# **Field Modification FM13016F**

## **NX15 to NX400 Transmitters - Replacing the Single-Board Computer**

Issue 1.0 .....30 June 2026

A new generic SBC (Nautel Part # 207-8720-01) must be used as the replacement if the original fails. The new SBC is electrically compatible, but depending on the vintage being replaced, there are physical differences in the connector locations/styles.

Figure SD-3: NX200 Transmitter – Control/Monitor Stage

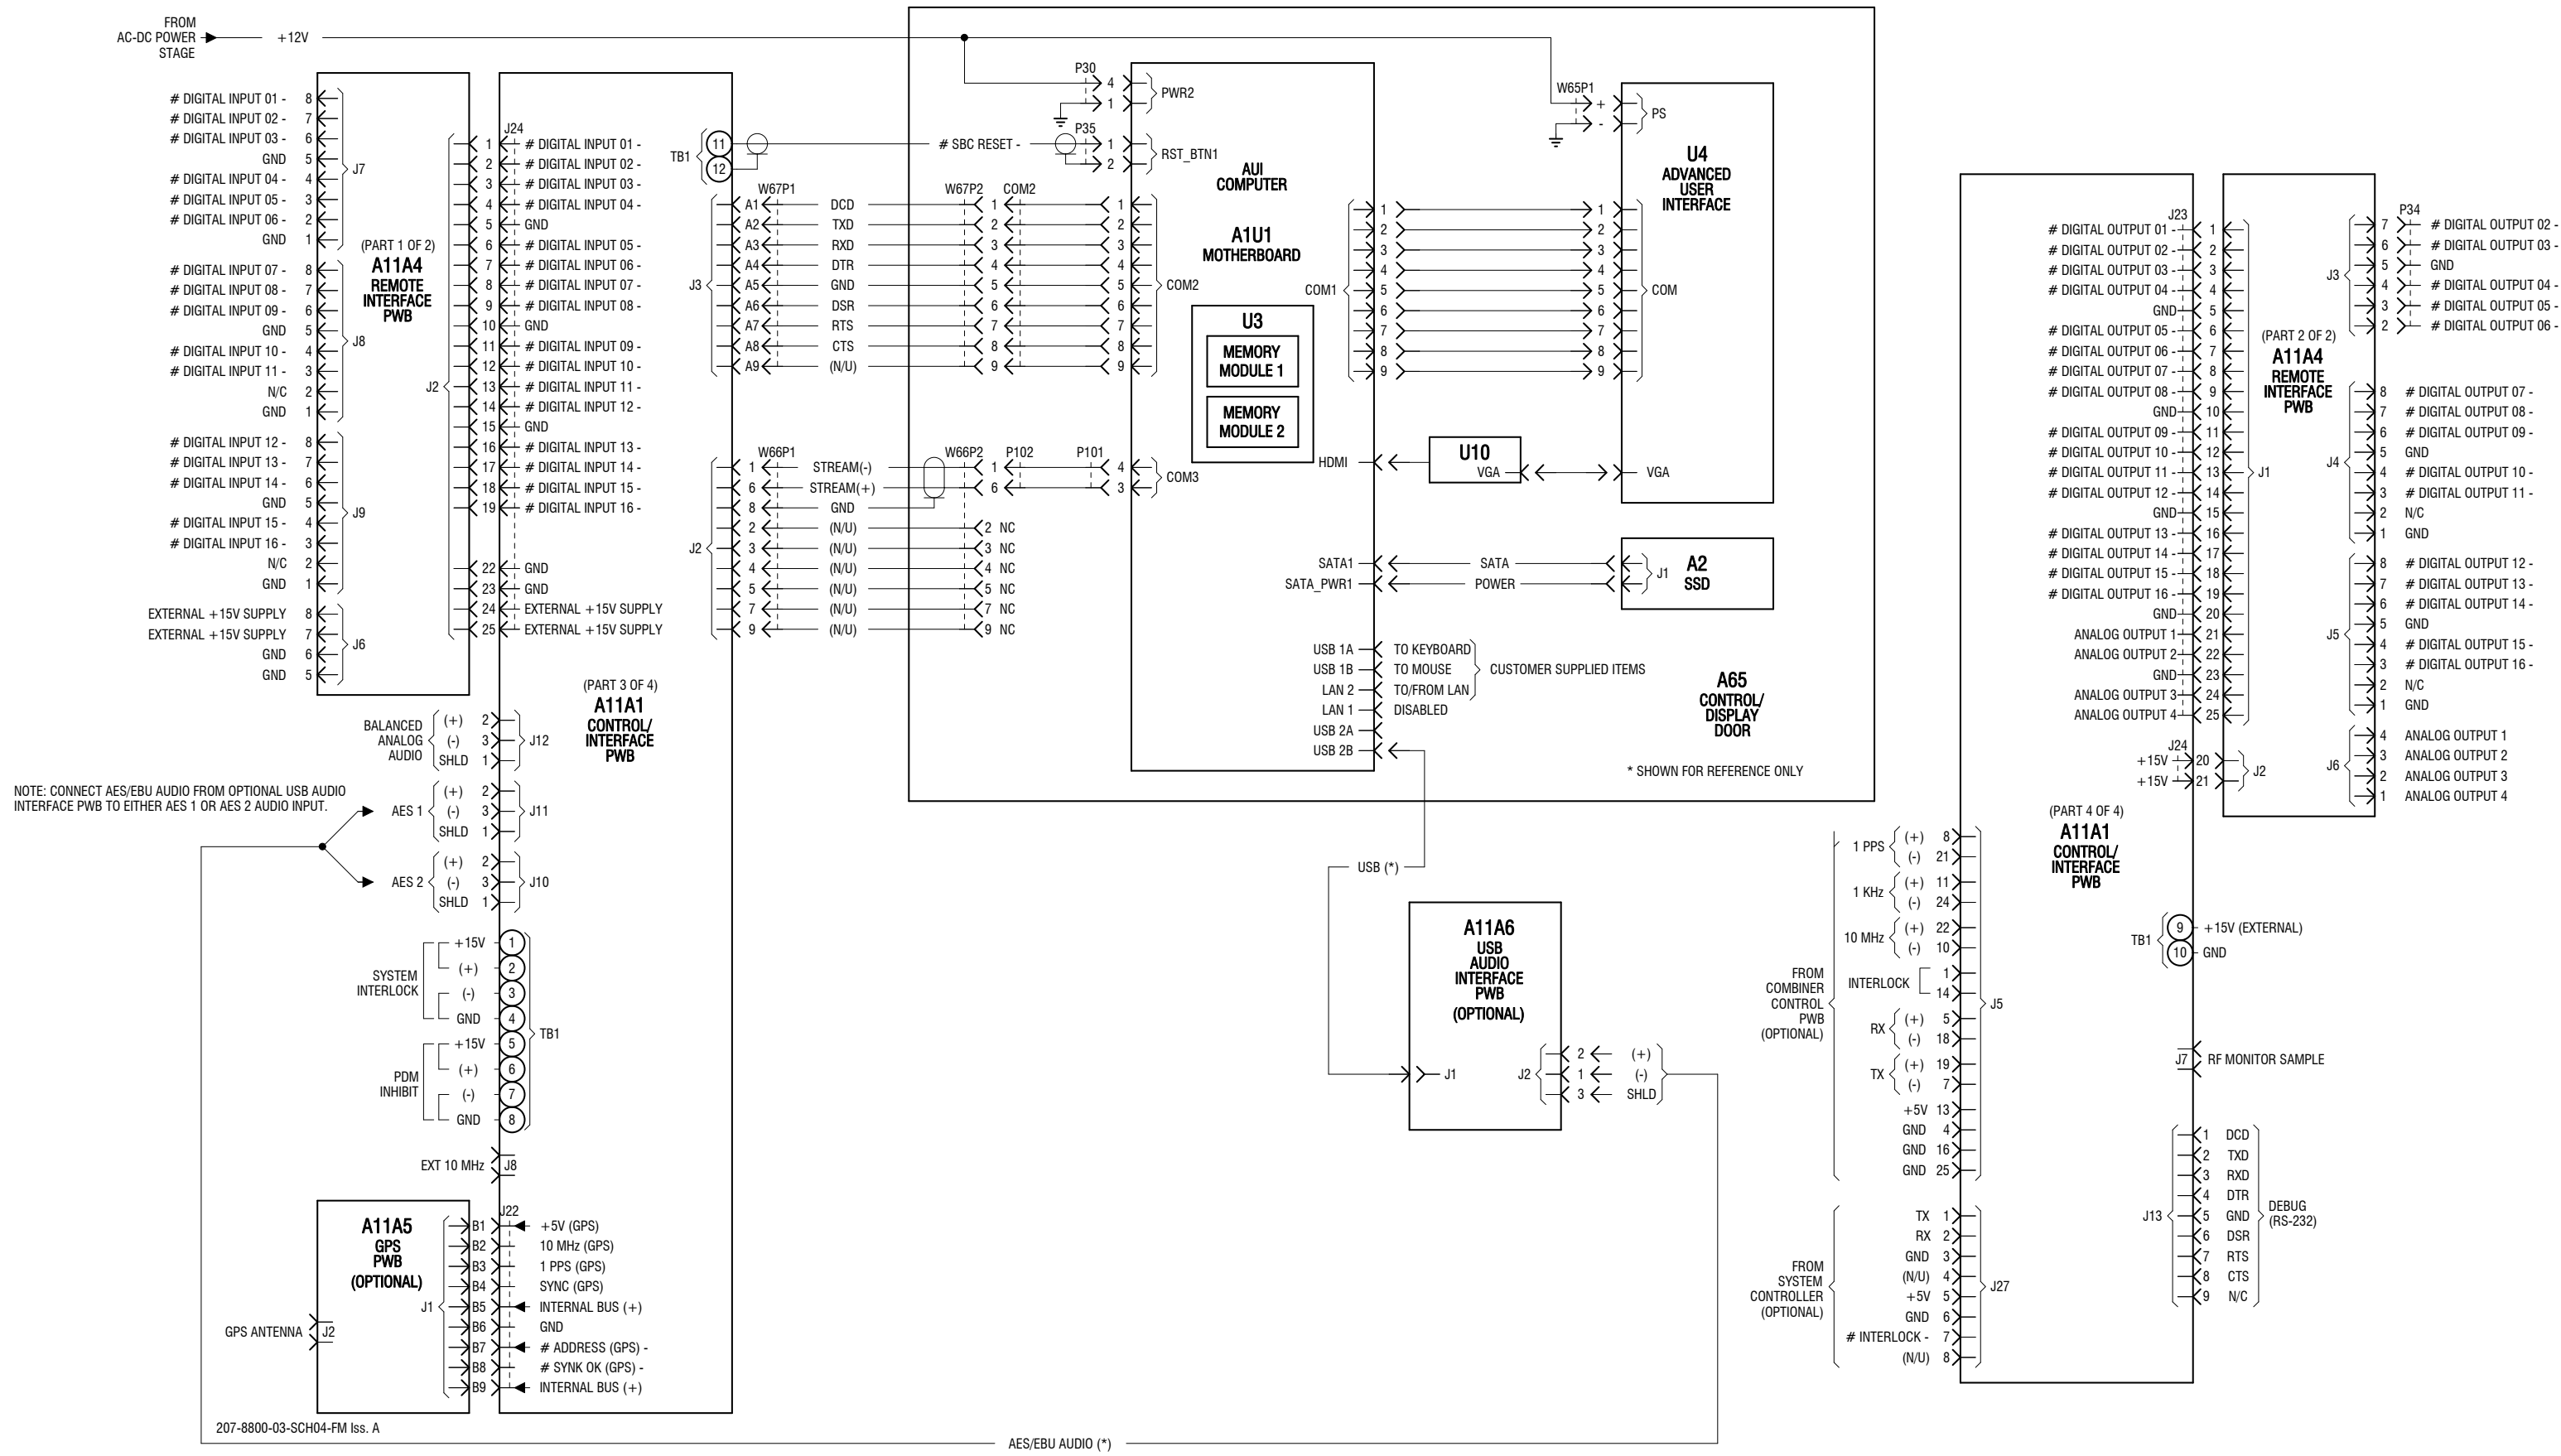
- Insert the applicable replacement Electrical Schematic included in this document and discard the old schematic:

Electrical Schematic SD-3 - Control/Monitor Stage in the NX Troubleshooting Manual with the applicable schematic provided with this document.
